**INTERIM CHANGE NOTICE  
(ICN)**

| <b>A. Document No.:</b> PNNL-13023   | <b>Revision No.:</b> 1  | <b>Effective Date of ICN:</b><br>October 2004     |
| <b>Document Title:</b> <i>RCRA Groundwater Monitoring Plan for Single-Shell Tank Waste Management Area A-AX at the Hanford Site</i>  |   | <b>Change Requested By:</b><br>S. M. Narbutovskih |

**Figure 1.2.** Location Map of WMA A-AX and Surrounding Facilities

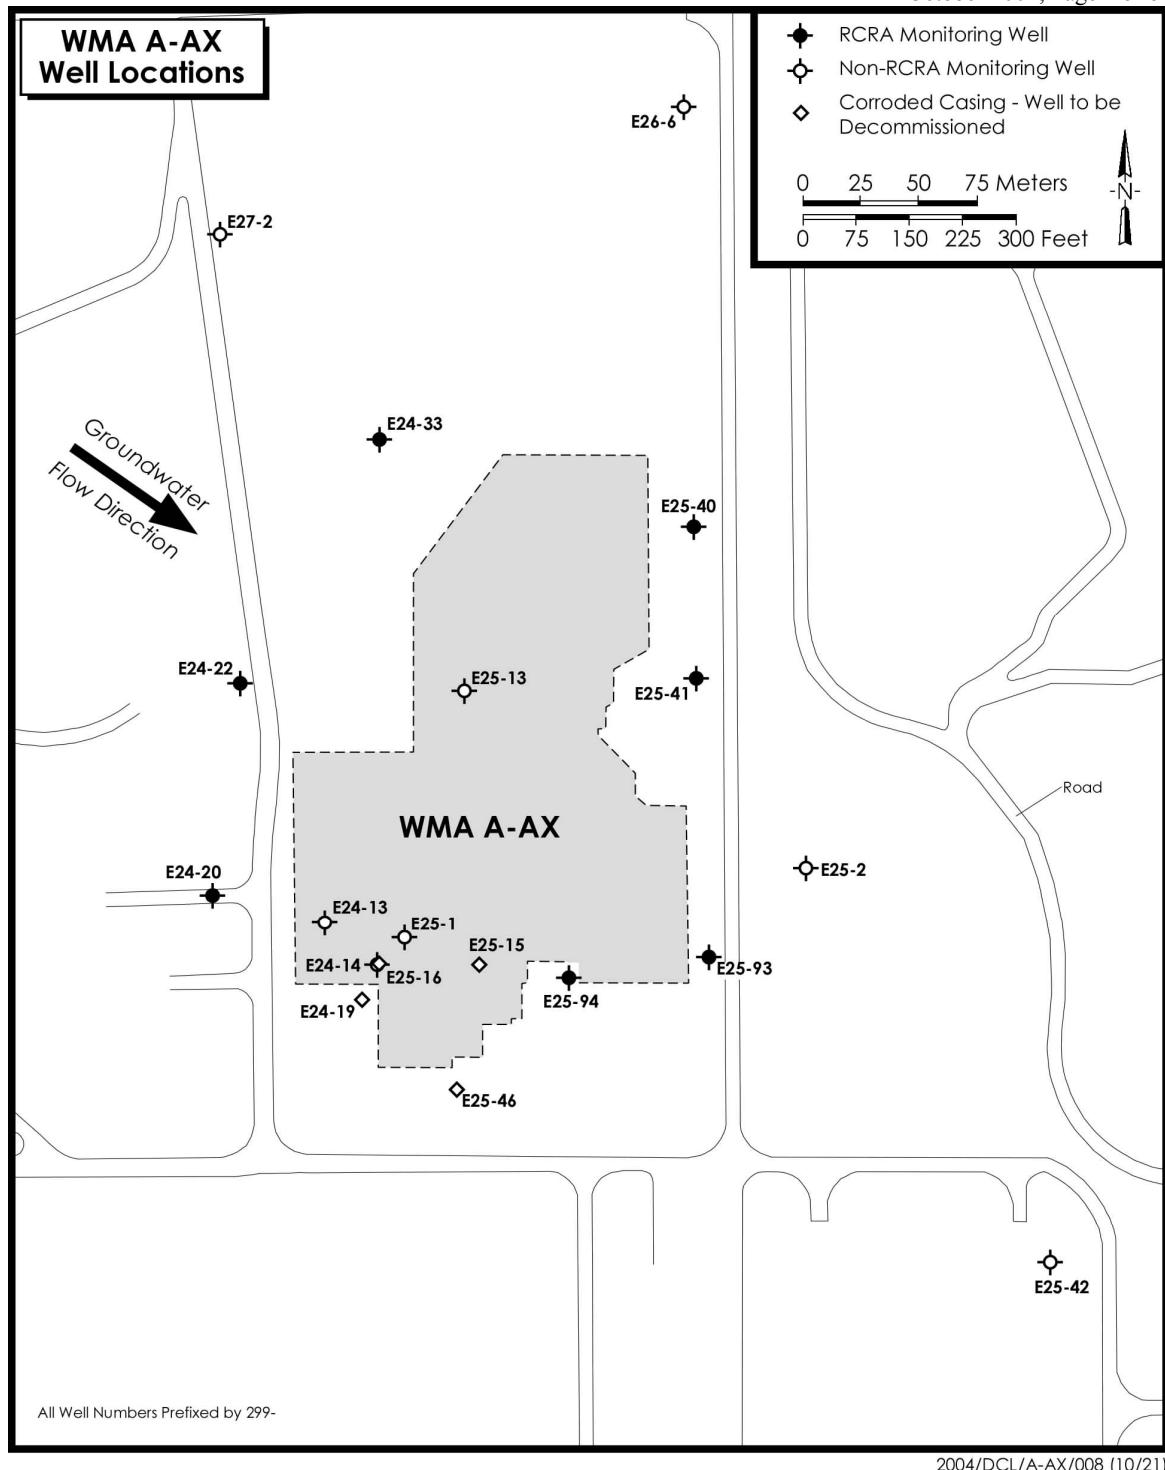
| <b>D. Reason for Change/Description of Change:</b><br><ol style="list-style-type: none"><li>(1) <b>Reason for Change:</b> Update groundwater quality monitoring plan at WMA A-AX (PNNL-13023) to document the addition of two newly installed downgradient wells and two newly installed upgradient wells. The monitoring network is updated to reflect the addition of these new wells.</li><li>(2) Replace Figure 1.2 on page 1.3 with the attached Figure 1.2.</li><li>(3) Remove page 4.3 with Table 4.1; replace with the attached page 4.3 with Table 4.1 to document the addition of 4 newly installed wells to and the removal of 2 wells from the monitoring network.</li><li>(4) Add Plates 4 and 5 at the end of the document.</li></ol><br><b>Description of Change:</b><br><ol style="list-style-type: none"><li>(2) Replace Figure 1.2 on page 1.3 with the attached Figure 1.2.</li><li>(3) Remove page 4.3 with Table 4.1; replace with the attached page 4.3 with Table 4.1 to document the addition of 4 newly installed wells to and the removal of 2 wells from the monitoring network.</li><li>(4) Add Plates 4 and 5 at the end of the document.</li></ol> |   |   |

The present network has been expanded to consist of seven RCRA Standard wells and one older carbon-steel well (Figure 1.2). Two newly installed upgradient and two newly installed downgradient wells have been added to the network. However, two wells, 299-E24-19 and 299-E25-46, were removed from the network due to corroded casing. Currently eight wells, as listed in Table 4.1, are used for monitoring the groundwater quality. The water level measurements are made semiannually over a one hour interval to eliminate daily earth tide effects and to reduce barometric effects due to changing atmospheric pressure.
